**TOWN OF BAY HARBOR ISLANDS
PLANNING AND ZONING BOARD**

October 19, 2016

FINAL AGENDA

**TOWN OF BAY HARBOR ISLANDS
COMMUNITY DEVELOPMENT
MEMORANDUM**

2nd LEVEL PARKING & LOBBY FLOOR PLAN

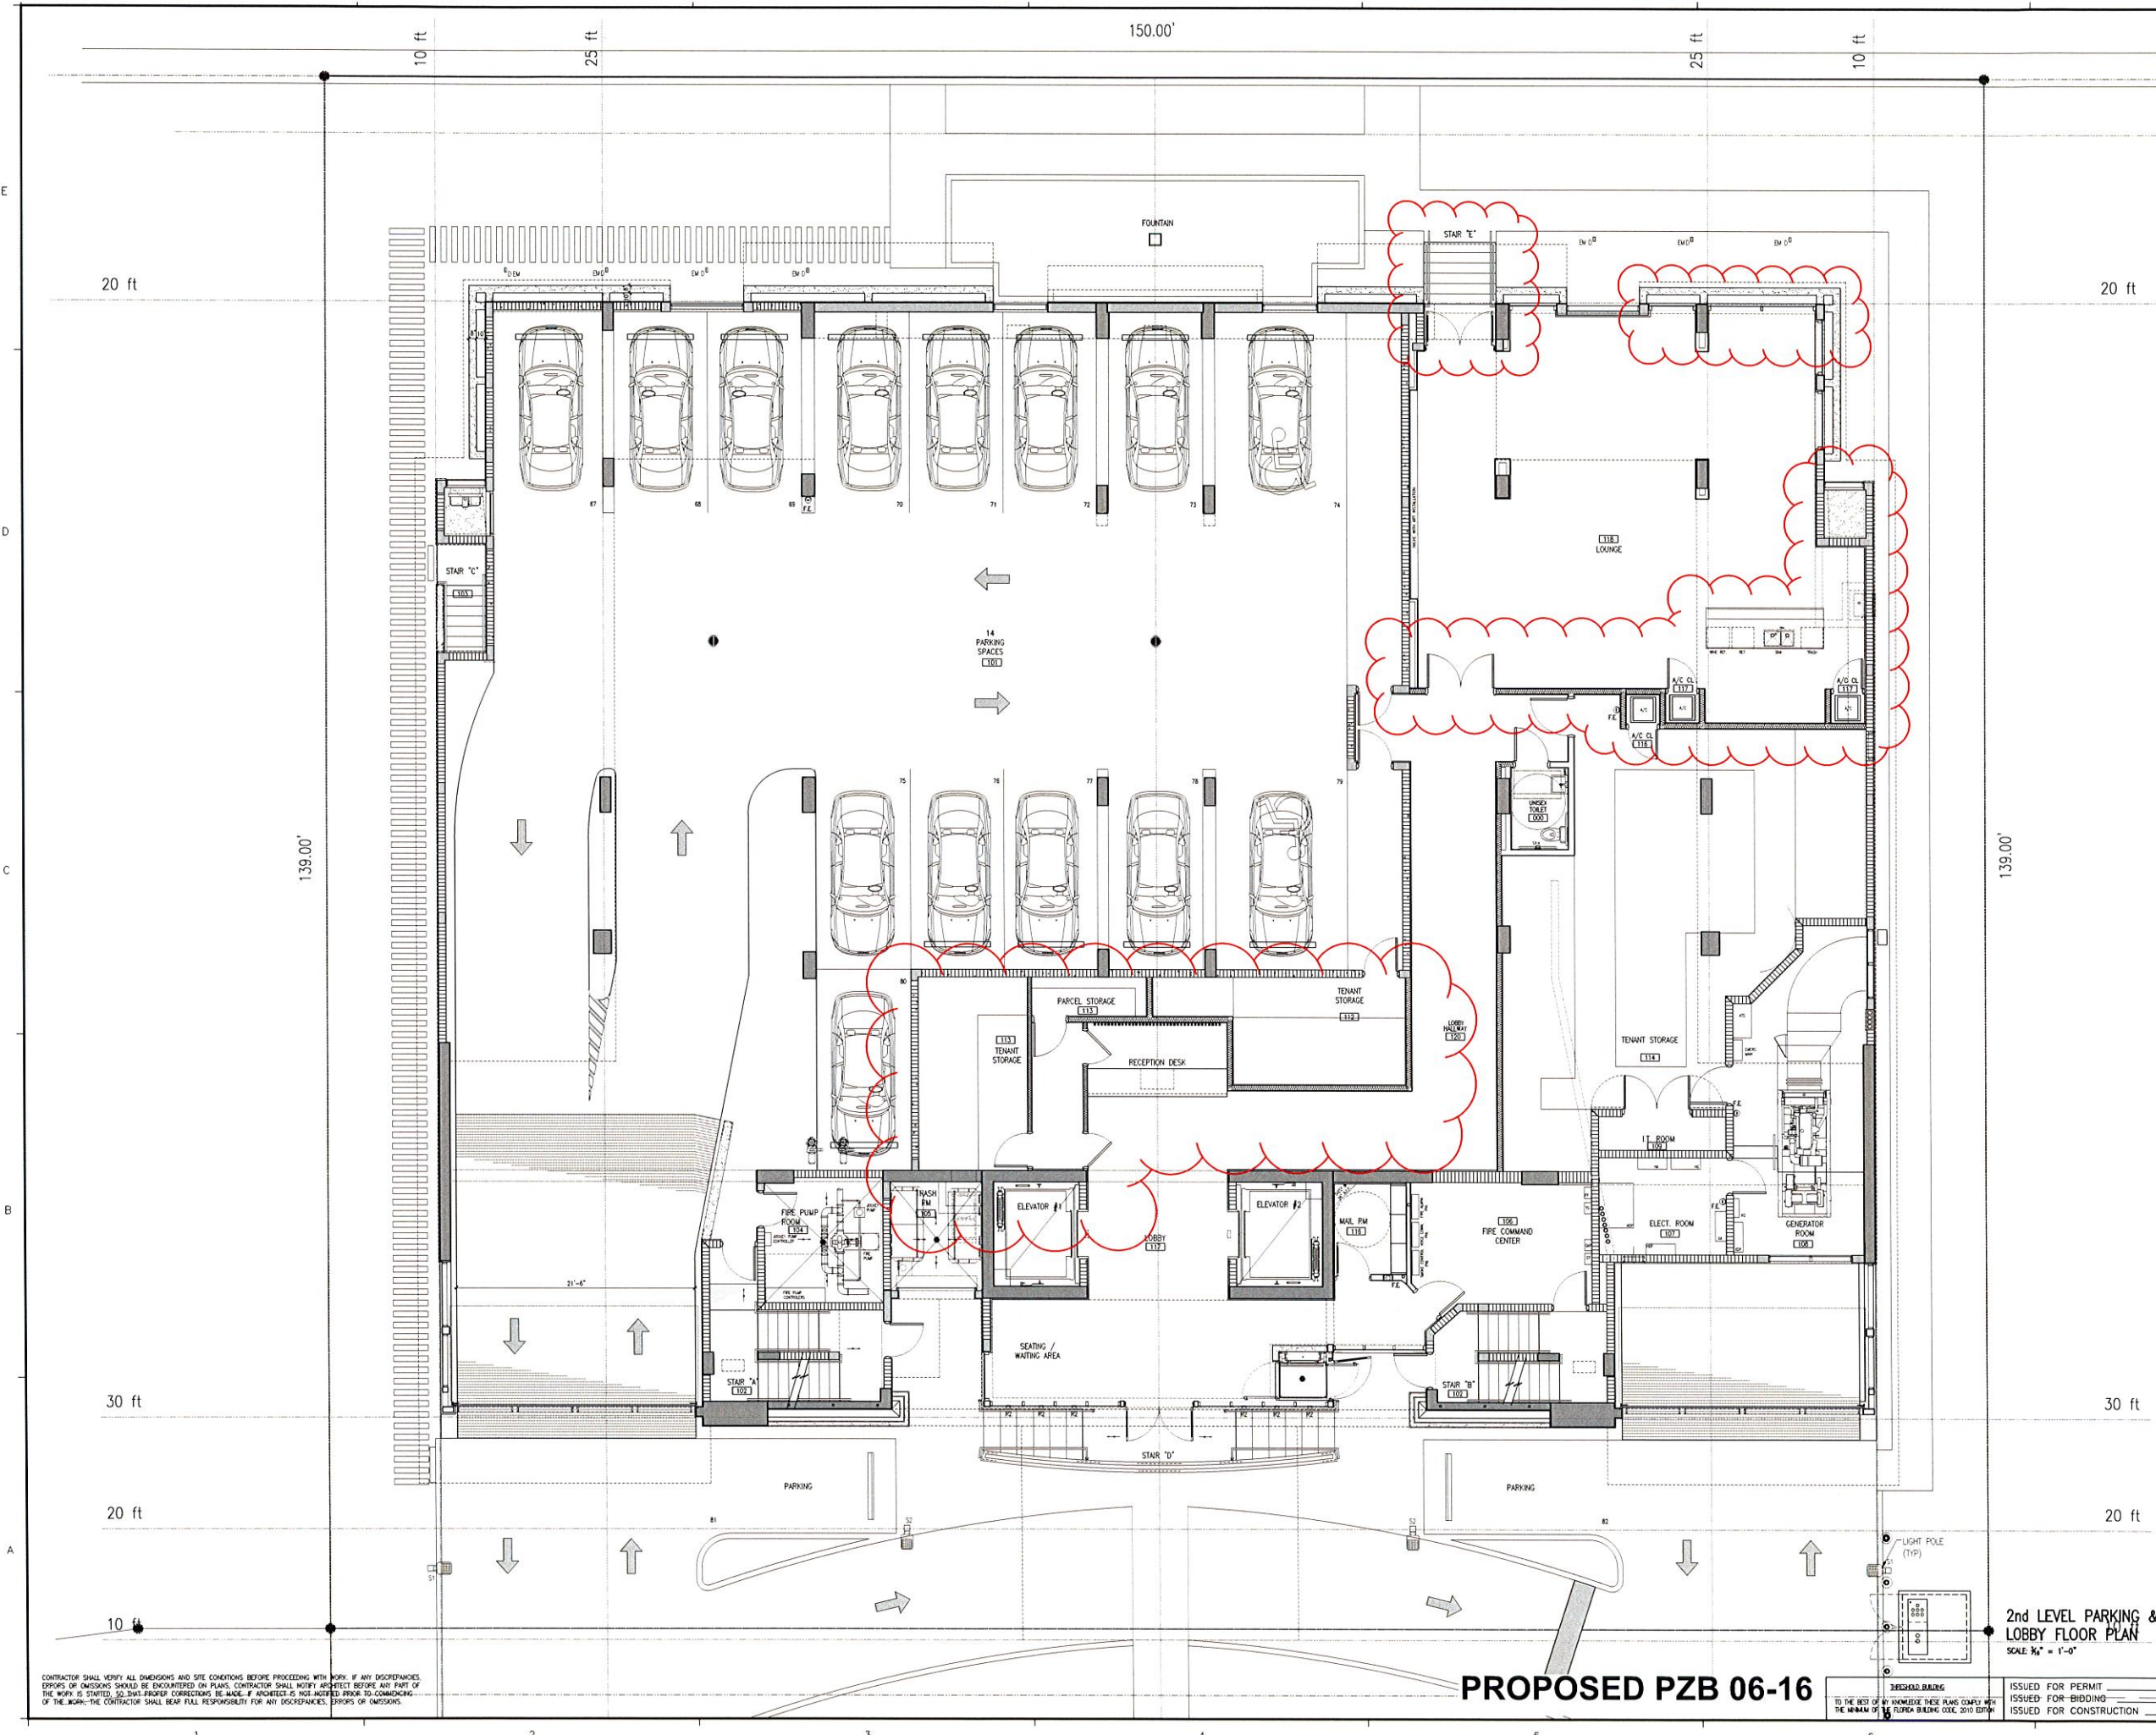
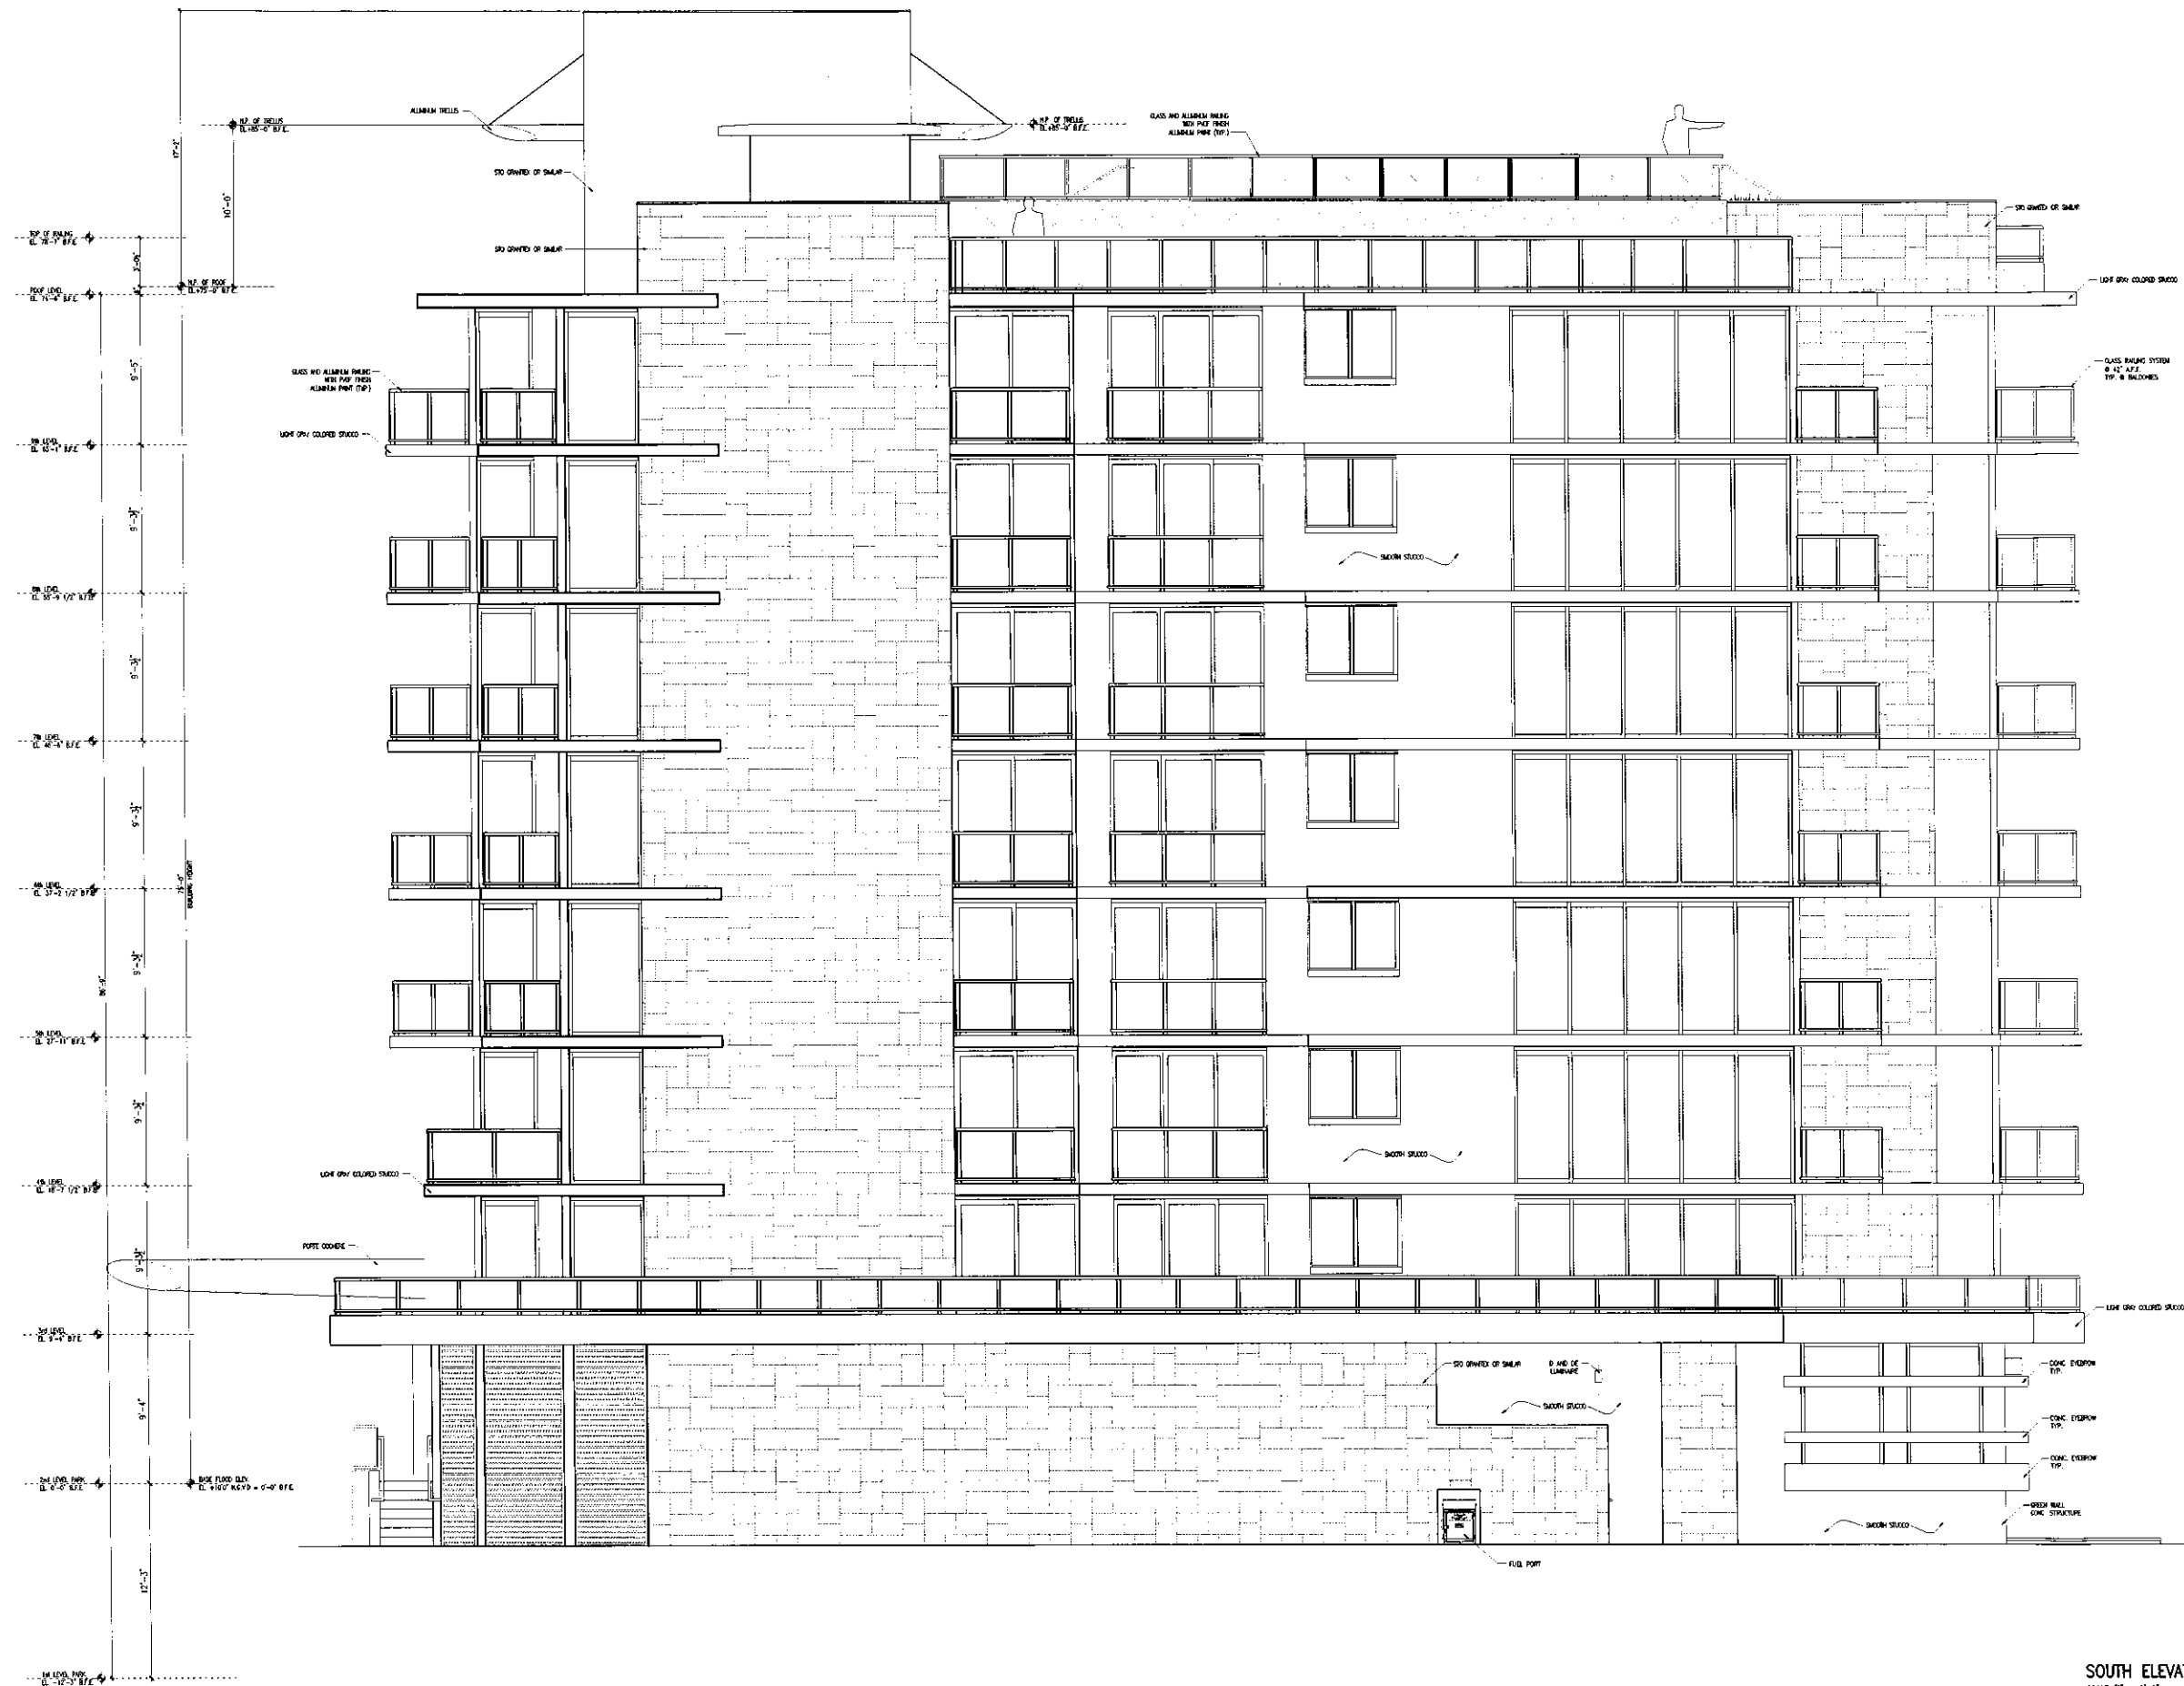
- 1) The layout of the parking garage / common floor areas has changed slightly from the PZB approved plans. A few interior areas were shifted. Most notably, the exit staircase from the second level on the south side was removed and the second floor exterior staircase leading to the rear yard from the lounge has been altered. **PZB approval is being requested for the new revised design.**

- Lounge 2nd Level Floor Plan: Stairs @ South was removed & East was relocated, Façade @ south and East, Interior Walls, Kitchen isle, a/c closets was modified
(See PROPOSED plans: Floor Plan A-1.12, South Elevation A-3.03, East Elevation A-3.03, Render R-2)
- Reception Desk & tenant storages 2nd Level Floor Plan modified
(See PROPOSED plans: Floor Plan A-1.03)
- Windows 3rd to 9th Level: Bathrooms and closet in all units @ East Elevations
(See PROPOSED plans: East Elevations A-3.03)
- Louver @ Generator Room 2nd Level Floor Plan & South Elevation
(See PROPOSED plans: Floor Plan A-1.03, South Elevation A-3.02)
- Roof: Trellis, Planters, Fire Pit, Summer Kitchen, Sky Lounge, Hot Tub, Swimming pool modified
(See PROPOSED plans: Floor Plan A-1.12, South Elevation A-3.02, East Elevation A-3.03, Render R-2)
- Gravity wall was removed. (See PROPOSED Plan: A-1.03)
